Re: Nine Mile Point Unit 1  
Docket 50-220  
DPR-63

Your Inspection and Enforcement Bulletin 79-27 requested information regarding Loss of Non-Class IE Instrumentation and Control Power System Buses During Operation. The attachment to this letter addresses your request.

RESPONSE TO  
INSPECTION AND ENFORCEMENT BULLETIN 79-27  
FEBRUARY 29, 1980

For details, see attached Figures VIII-2 and IX-2 from the FSAR, Supplement 2.

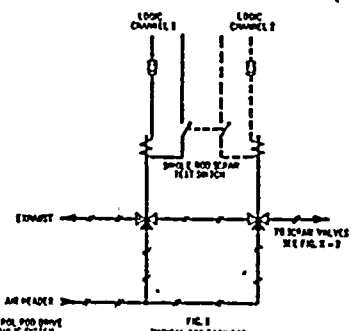
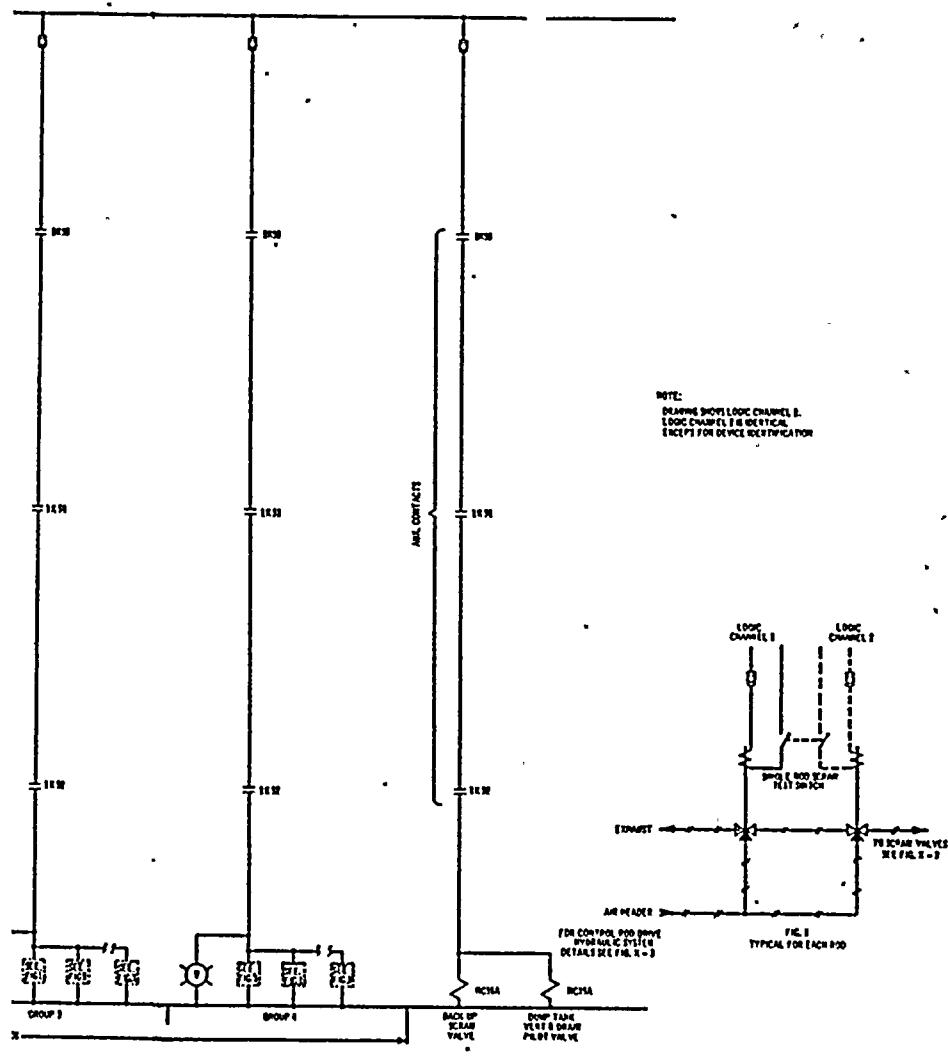
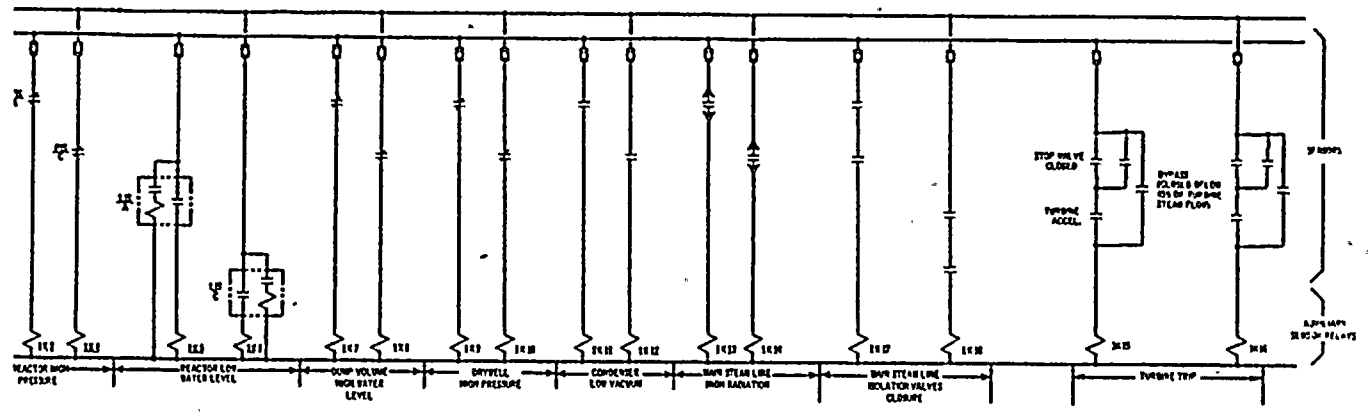
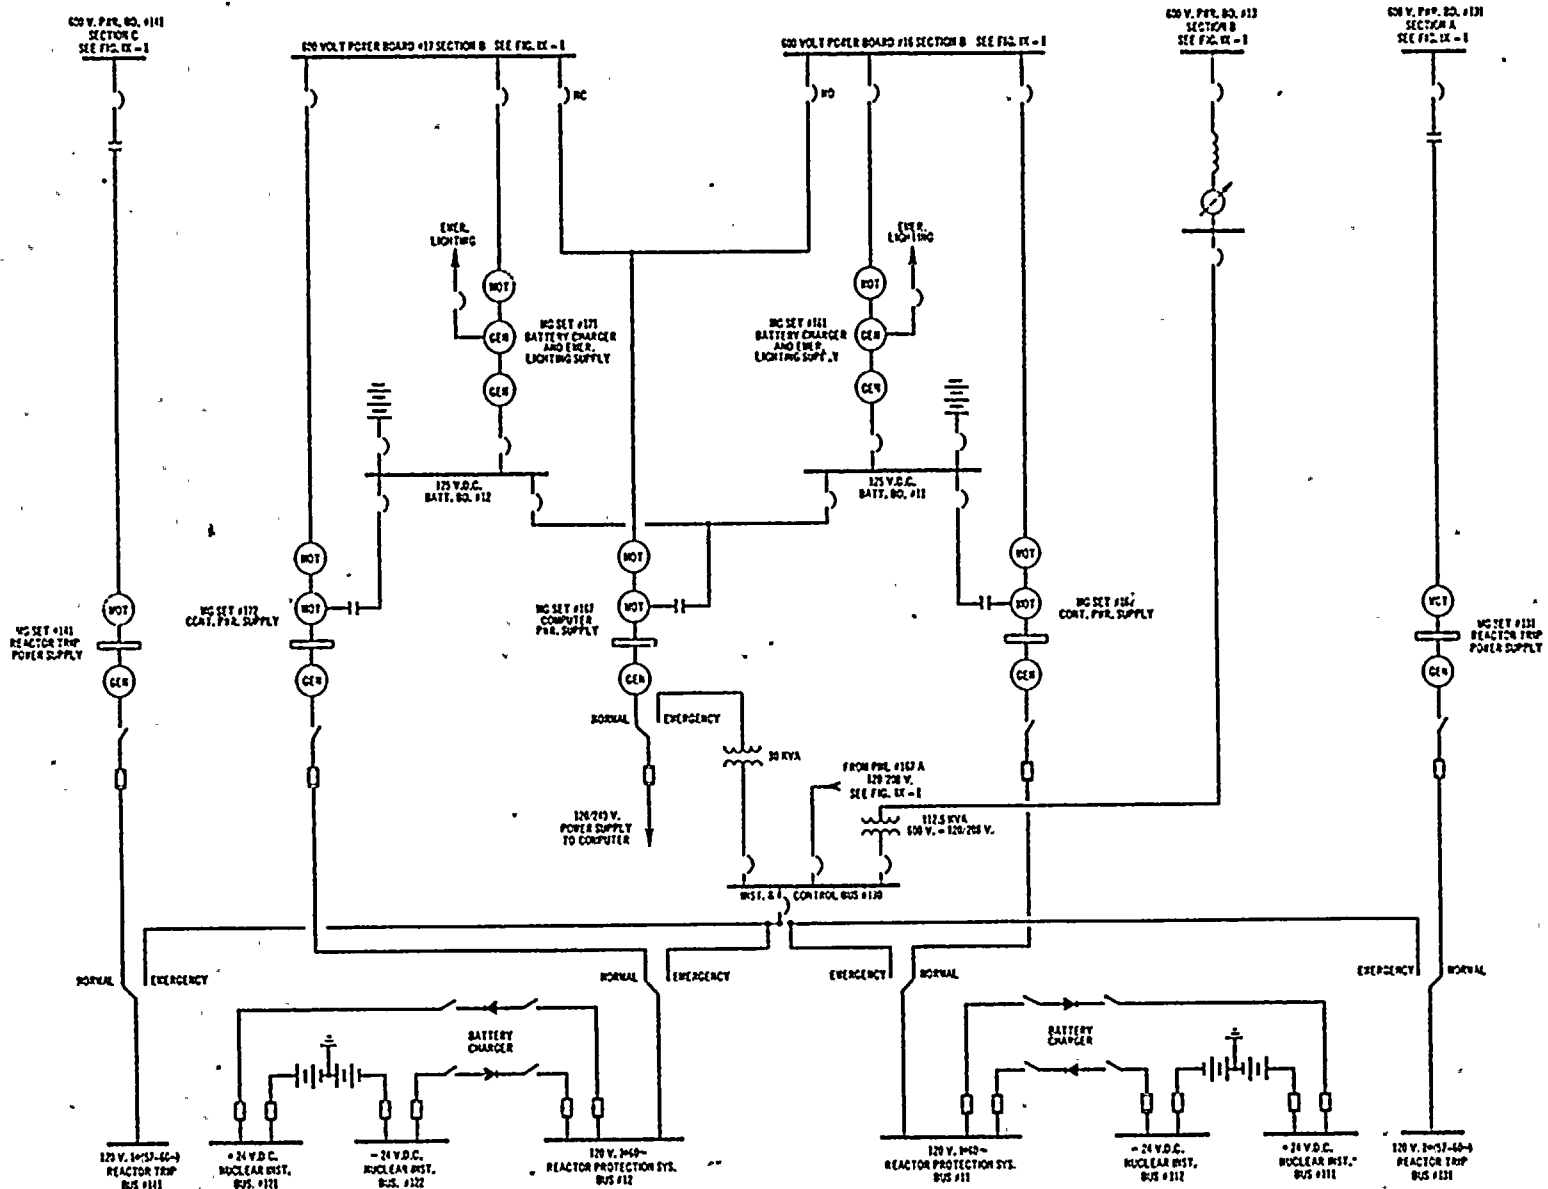
Review the Class 1-E and Non-Class 1-E buses supplying power to safety and non-safety related instrumentation and control systems which could affect the ability to achieve a cold shutdown condition using existing procedures or procedures developed under Item 2 below. For each bus:

- a. Identify and review the alarm and/or indication provided in the control room to alert the operator to the loss of power to the bus.
- b. Identify the instrument and control system loads connected to the bus and evaluate the effects of loss of power to these loads including the ability to achieve a cold shutdown condition.
- c. Describe any proposed design modifications resulting from these reviews and evaluations, and your proposed schedule for implementing those modifications.

Reactor trip buses 131 and 141 are redundant. Loss of power to either bus would result in a half scram. This would not affect cold shutdown.

Reactor protection system buses 11 and 12 are redundant. Loss of power to either bus would also result in a half scram. This would not affect cold shutdown. In addition, power is supplied by a continuous power supply M-G set which derives its power from either an AC or DC source, as shown on the attached figures.

Based upon this review, no design modifications are necessary at Nine Mile Point Unit 1.
